CIRCUIT COMPARISON

ChryslerScanner

Original schematic -> current circuit sets

Original: Daniel Laszlo, revision 2.4.0-1, 2026-01-05. Current: Rev C, 24 pages / 329 circuit-probe endpoints.

26 Integrated microSD logger

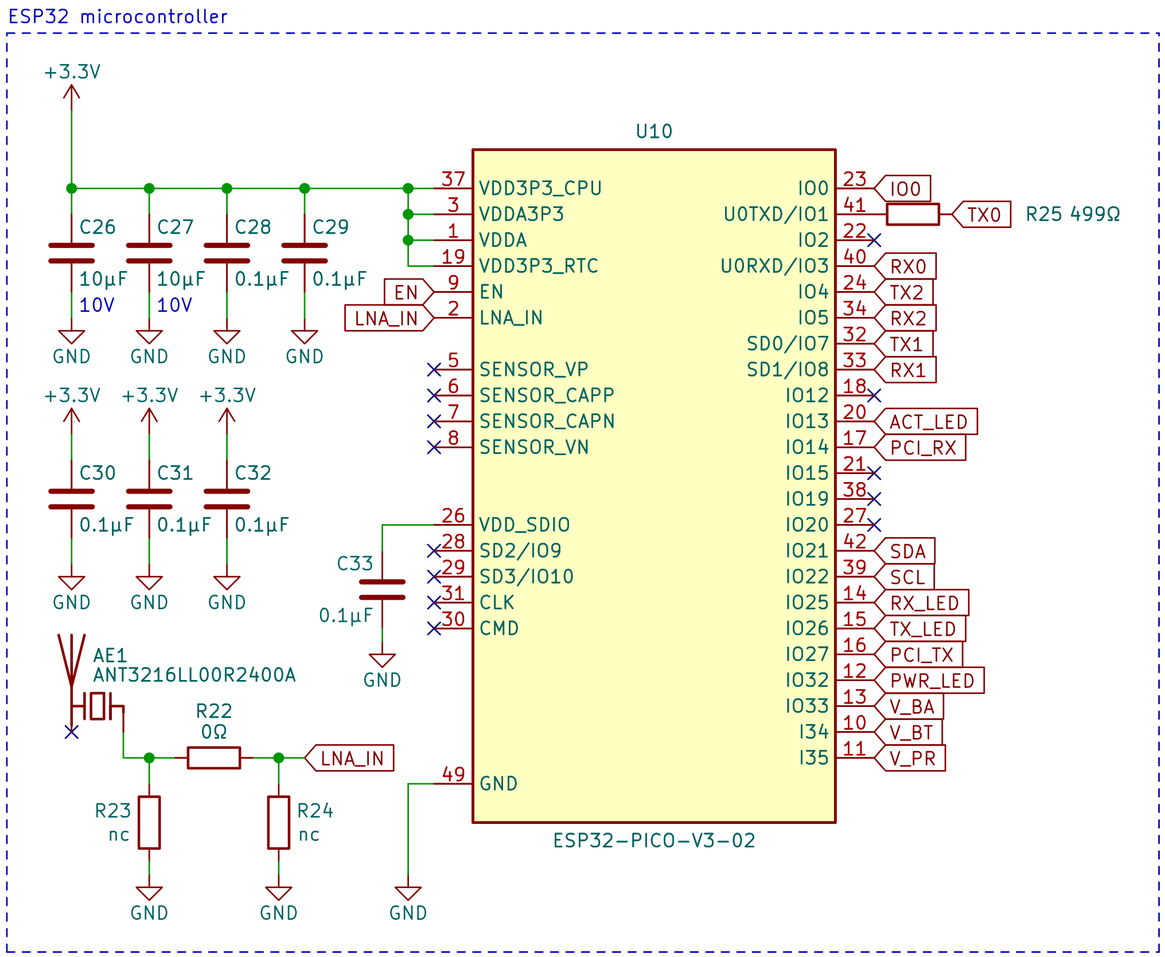
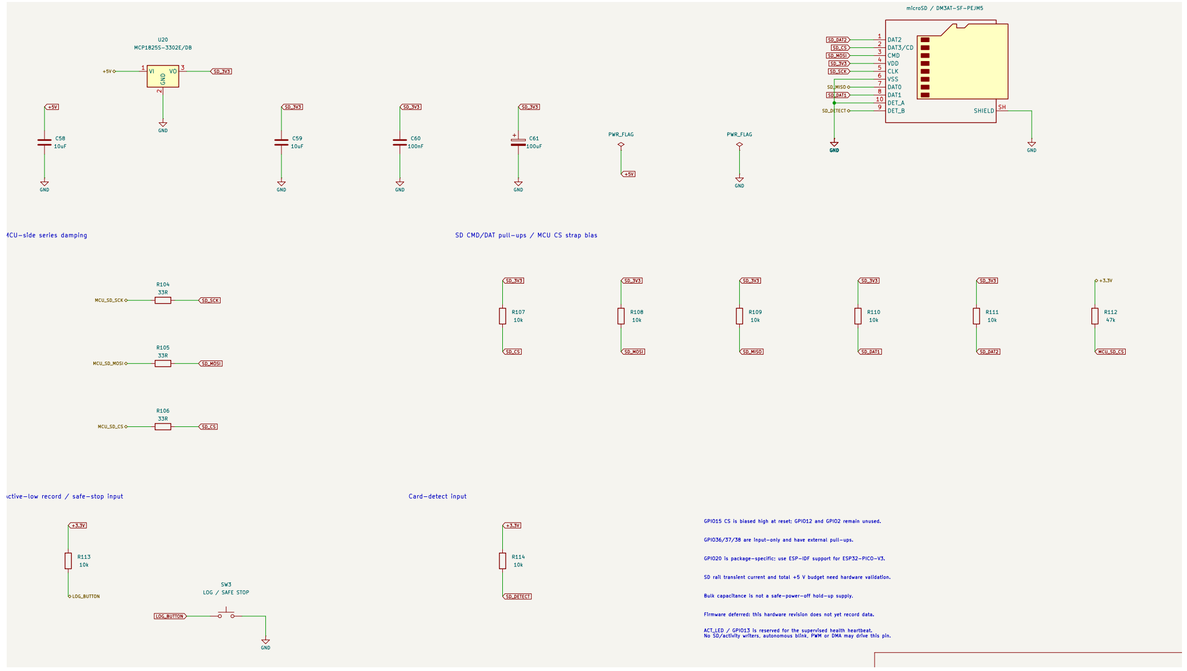
- There is no corresponding microSD block in the original drawing. U20, J4, C58-C61, R104-R114 and SW3 are later additions.
- SD_3V3 regulation, SPI resistors/pull-ups, card detect and logging control use previously unused MCU pins. C61 is now top-side; that physical move does not change the schematic circuit.

27 Added ADC power-off isolation

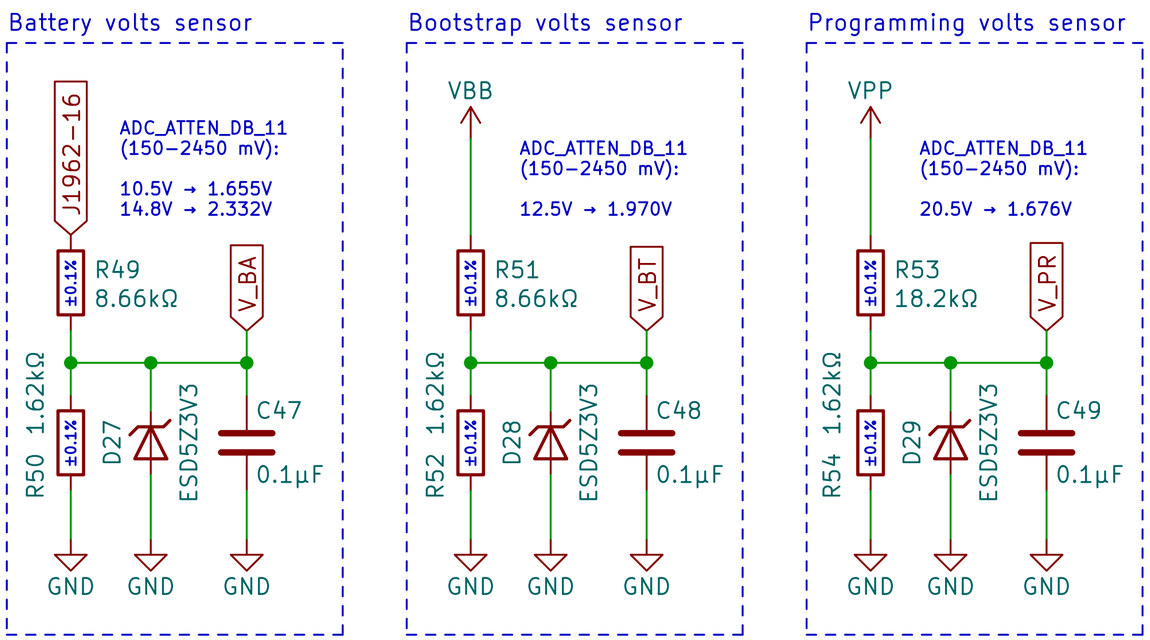
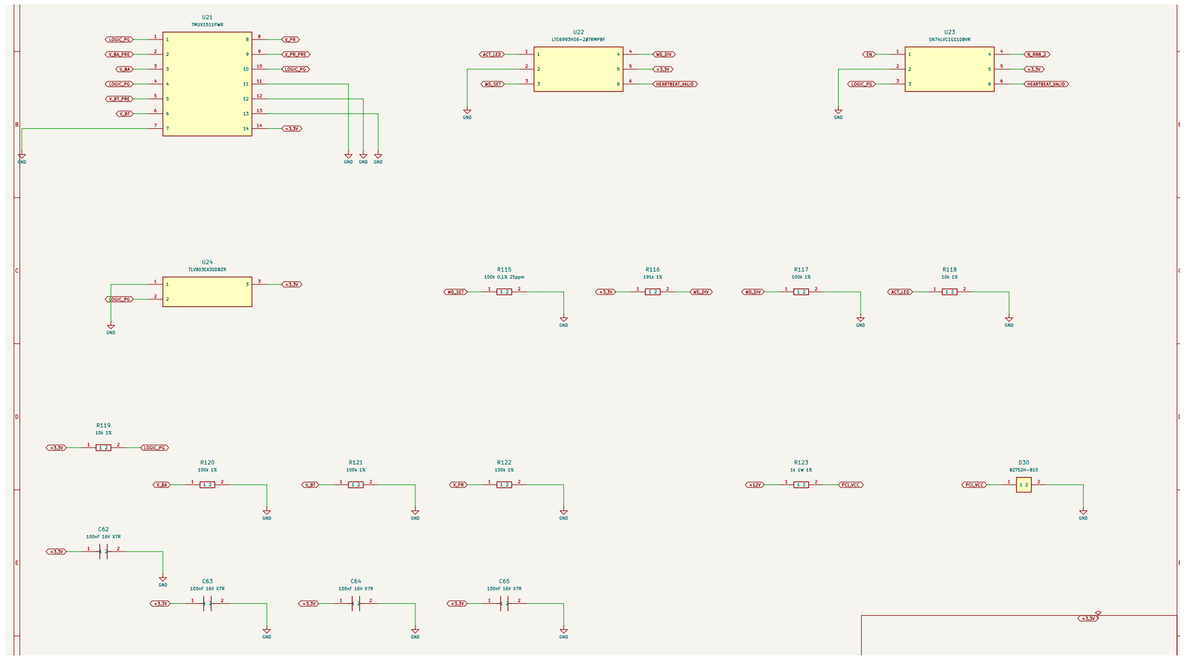
- U21 and R120-R122 are new. The original ADC paths now terminate on *_PRE nets before this isolation stage.
- The additions address powered-off MCU injection; they deliberately depart from the original direct ADC connection. See comparison 16 for the changed divider inputs/ratios.

28 Added supervisor, watchdog and hardware permit

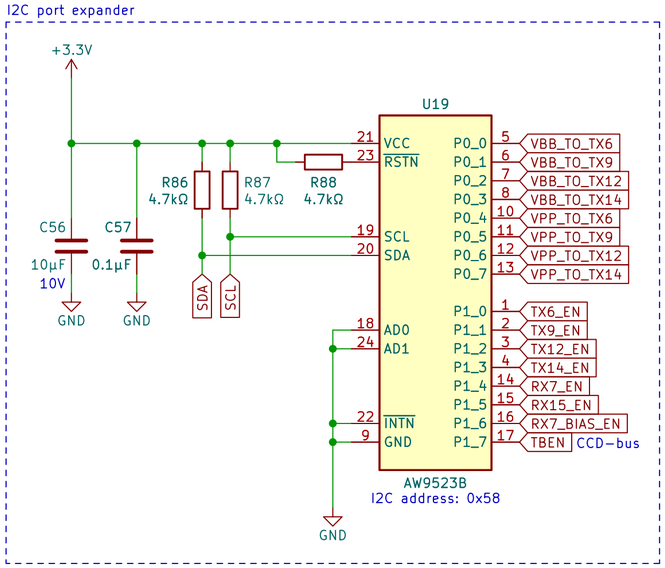
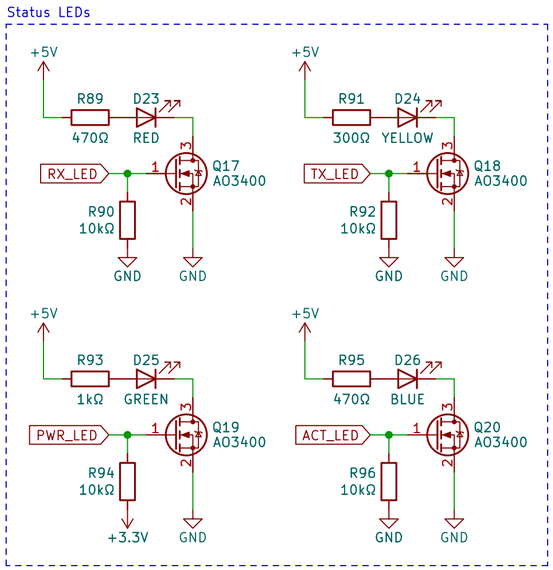
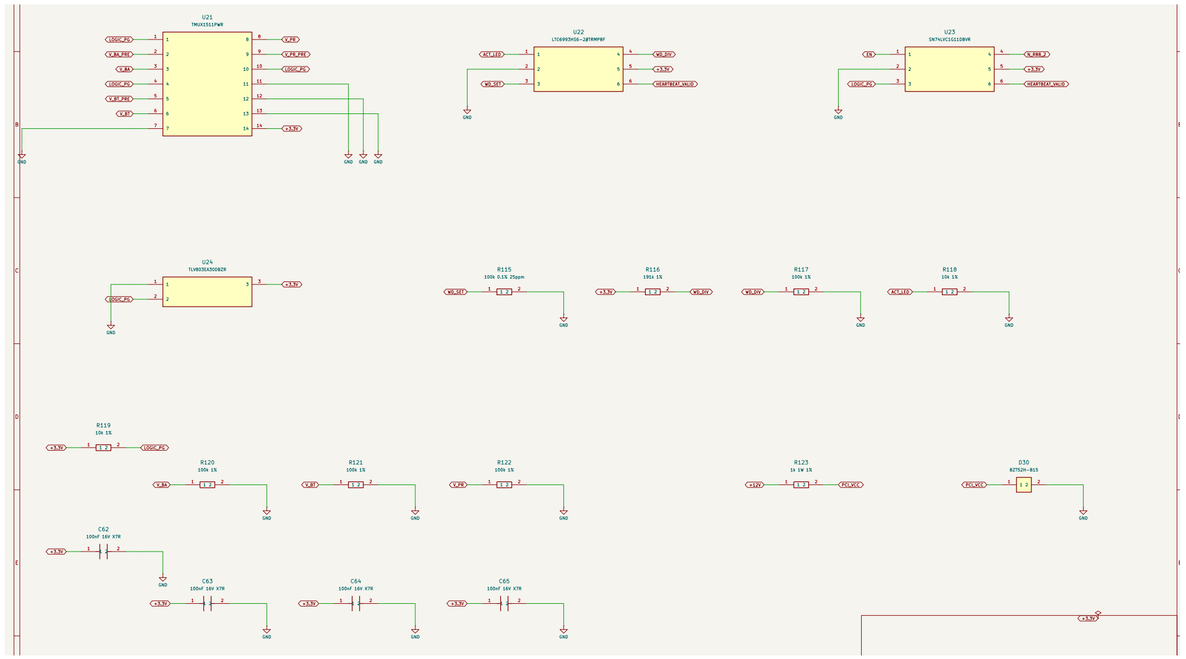
- U22-U24, R115-R119 and associated bypassing implement a new supervised permit, not an original circuit copied to another page.
- Dedicated ACT_LED health pulses and LOGIC_PG / HEARTBEAT_VALID govern N_R88_2. Firmware integration and measured timing remain required; the comparison is not a bench qualification.

29 Added PCI comparator supply clamp

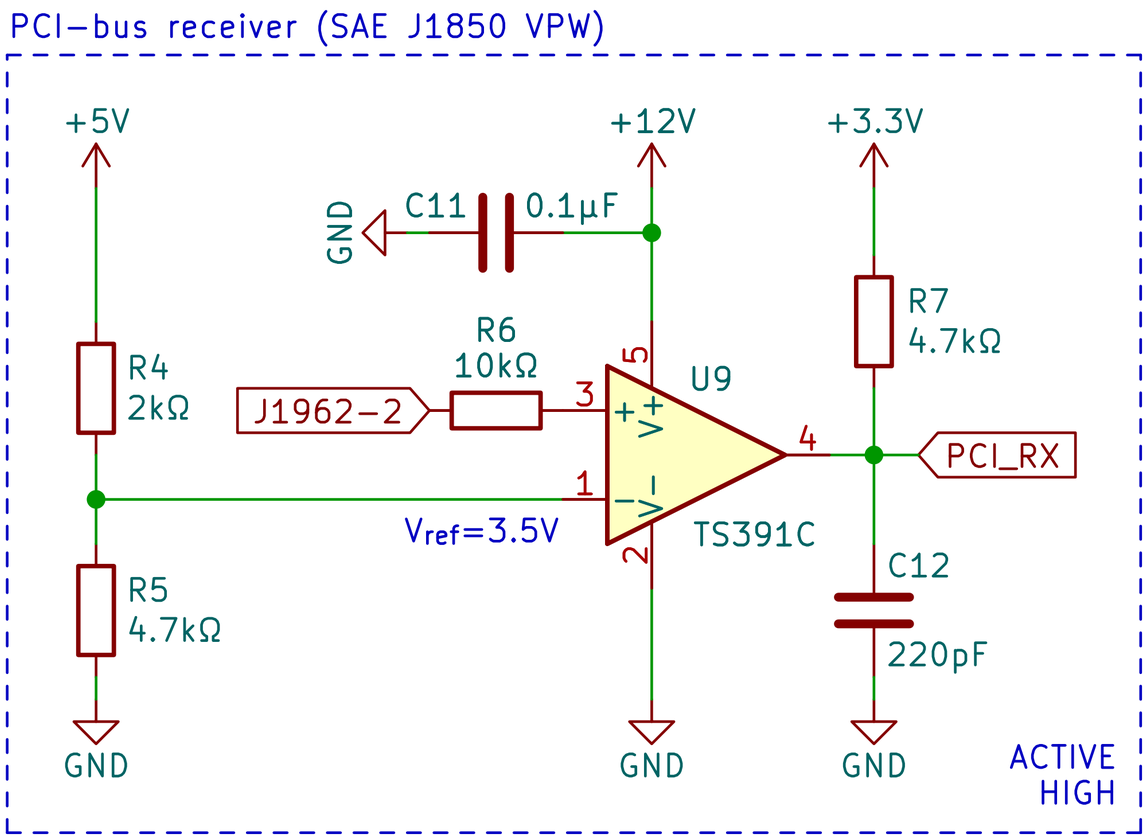
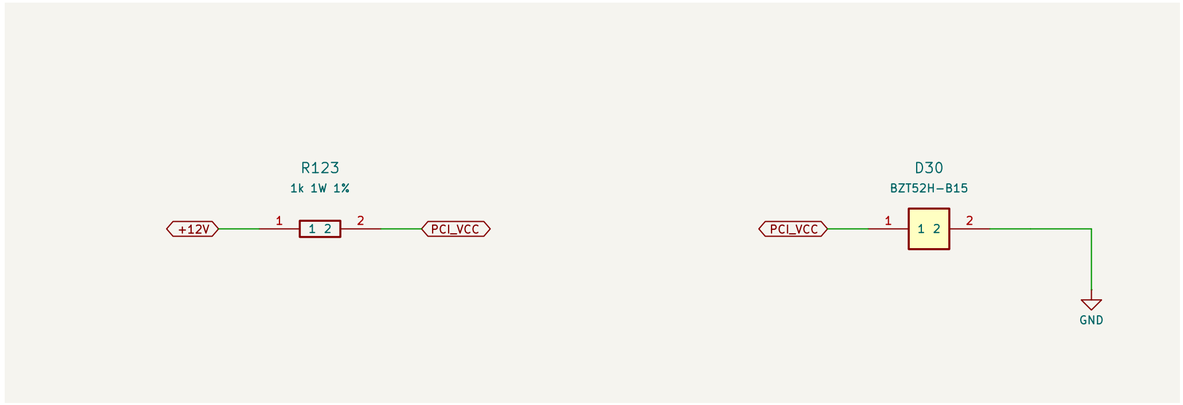
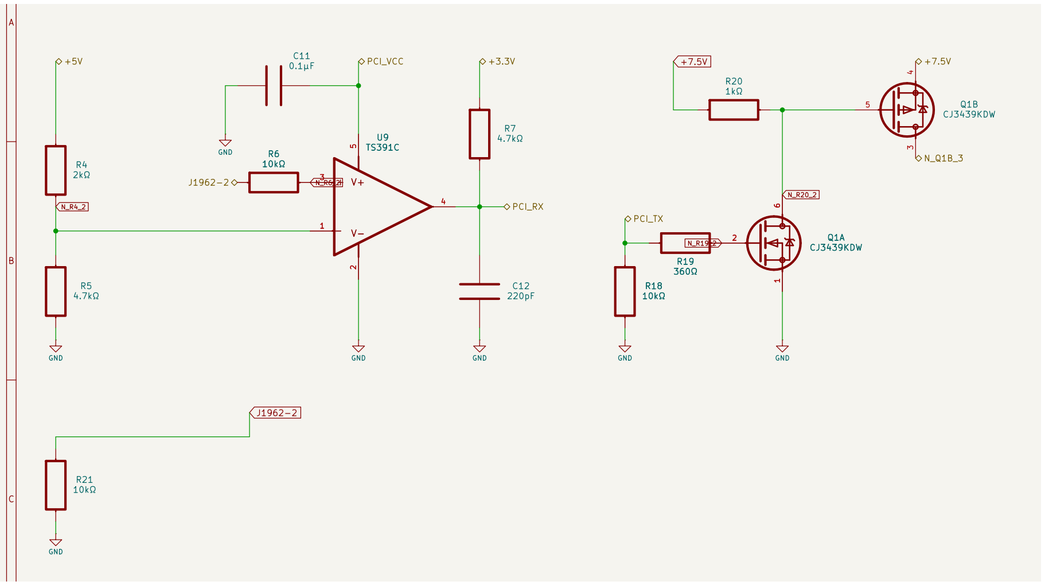
- R123 and D30 are new. U9.5 and C11.2 now use PCI_VCC rather than direct +12V.
- The original receiver function remains, while its supply protection is deliberately changed.

30 Hook test points and SPI probe pads

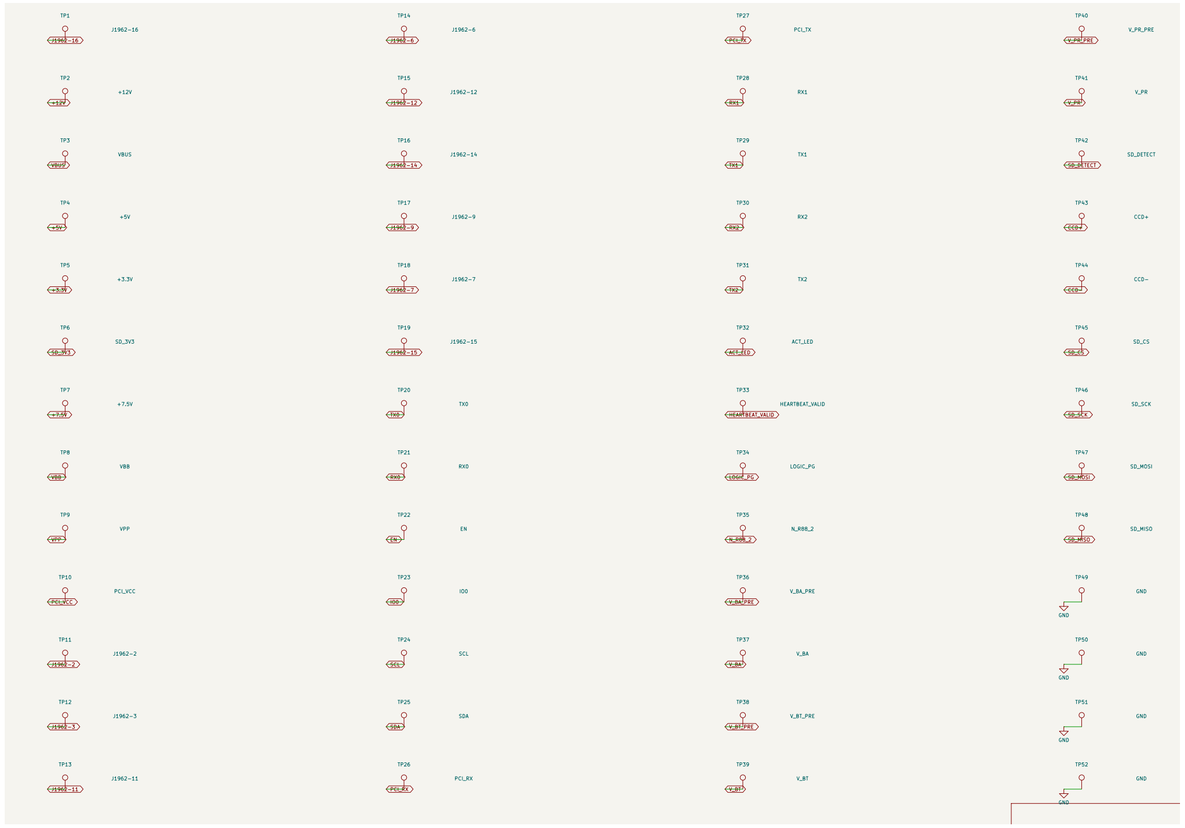
- The original PDF has no TP1-TP52 debug-access block. The current design adds 48 Keystone 5015 hook loops and four bare SPI pads, with four local ground clips.
- Page 24 and rev-c-testpoint-map.md identify every net. Existing circuit geometry is retained; new pads require 230 total filled/capped/planarized via sites in the current fabrication package.
